CL Claremont Business Park 2 Filing No. 1

GRADING AND EROSION CONTROL PLAN

GRADING & EROSION CONTROL PLAN
Claremont Business Park 2 Filing No. 1

EL PASO COUNTY FILE NO. SF-20-0014

URBAN LOCAL CROSS SECTION (PRIVATE)

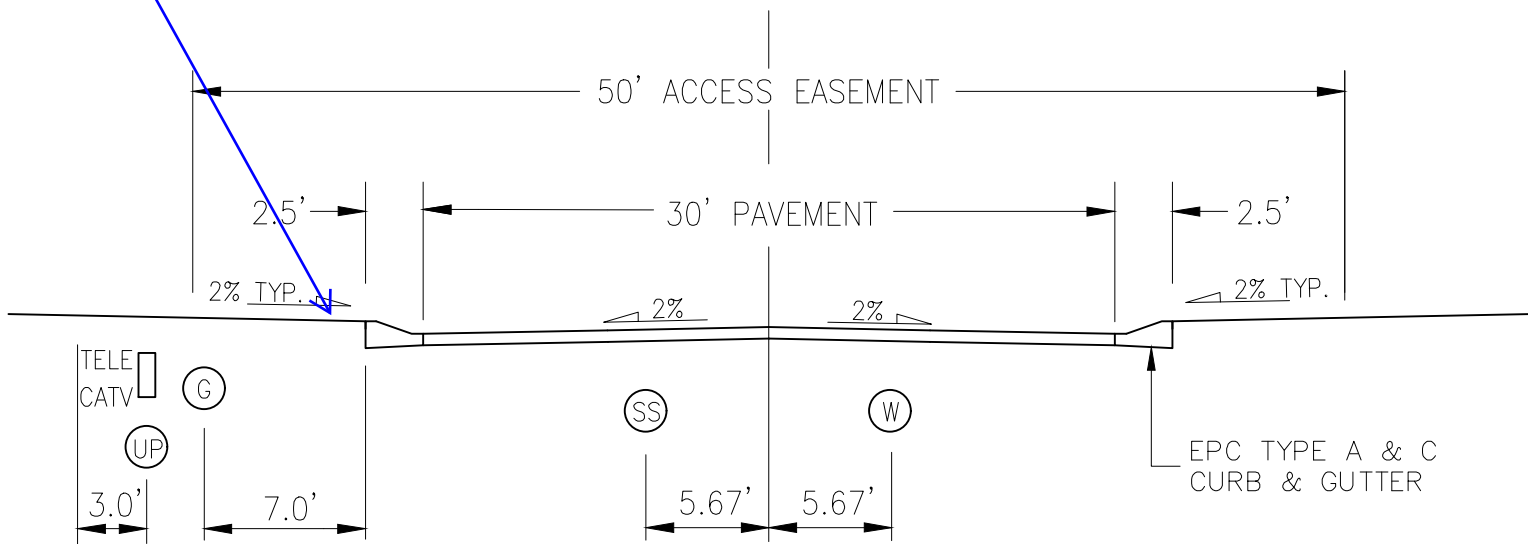
Provide sidewalk on the north side of the roadway as discussed in the conference call with staff.
